Refer to: HSA-10/CC-69C

In your October 15 letter, you provided copies of a report prepared by the Midwest Roadside Safety Facility (MwRSF) that documented a fifth test that was conducted on your Box-Beam Burster Energy Absorbing Bridge Pier Protection System, hereafter referred to as the BEAT-BP system. Information on the first four tests that you ran was submitted previously. Our review of those earlier tests resulted in changes that were incorporated into a final design and verified in the last test.

BEAT BRIDGE PIER PROTECTION SYSTEM

SYSTEM LAYOUT FOR 1219MM PIERS AT 6096MM SPACING AND TYPICAL APPLICATIONS

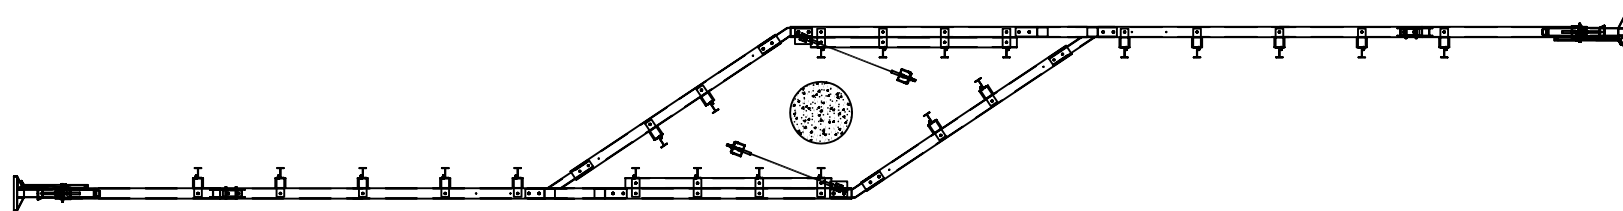
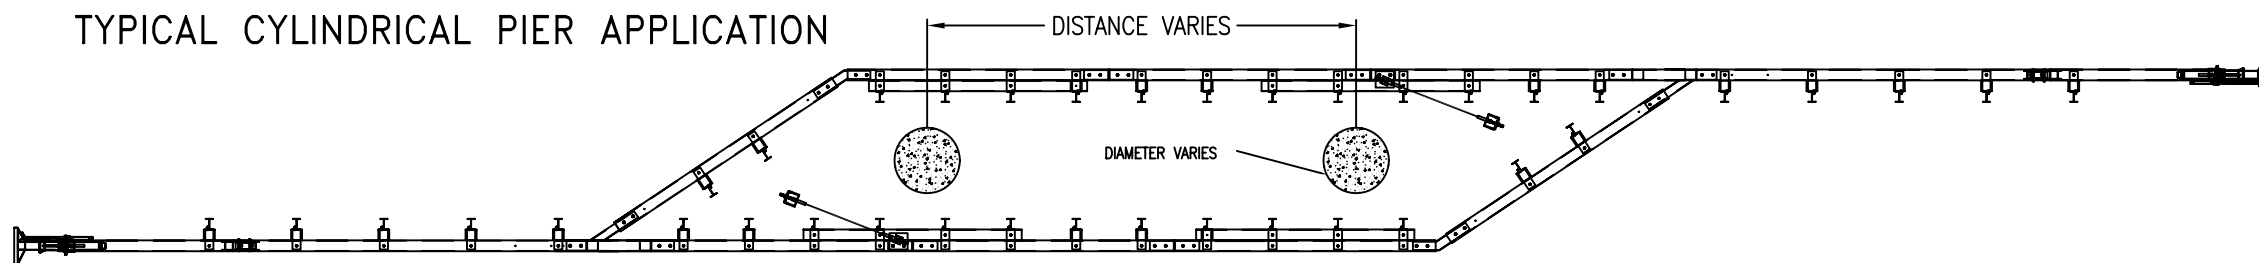
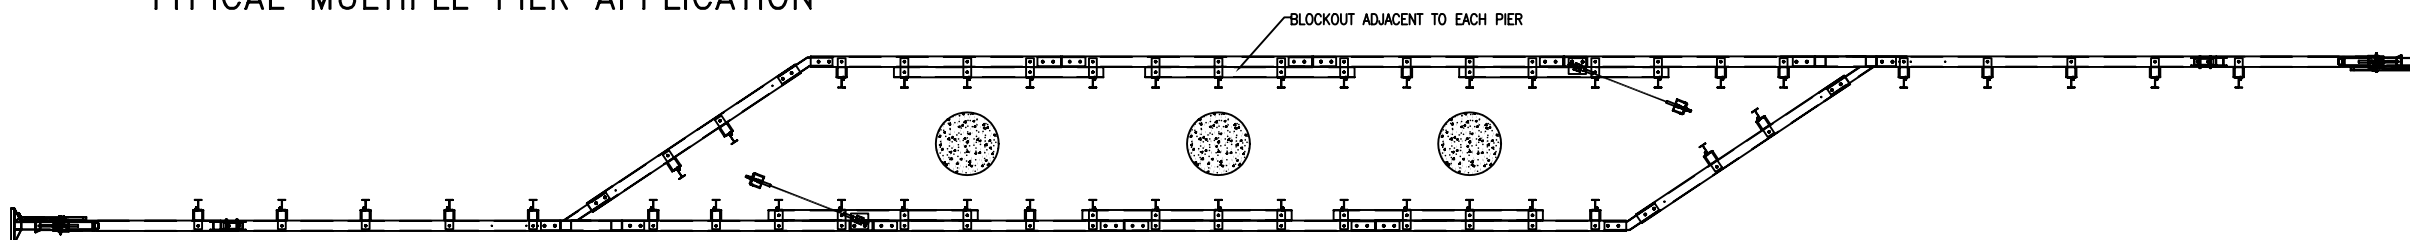
- You will be expected to supply potential users with sufficient information on design and installation requirements to ensure optimal performance. This information should include, but is not limited to, the need for a minimum eight-inch offset from a shielded pier or support and the necessity that the BEAT BP system be installed on a slope no steeper than 10:1 (as per note 7 on Enclosure 1).
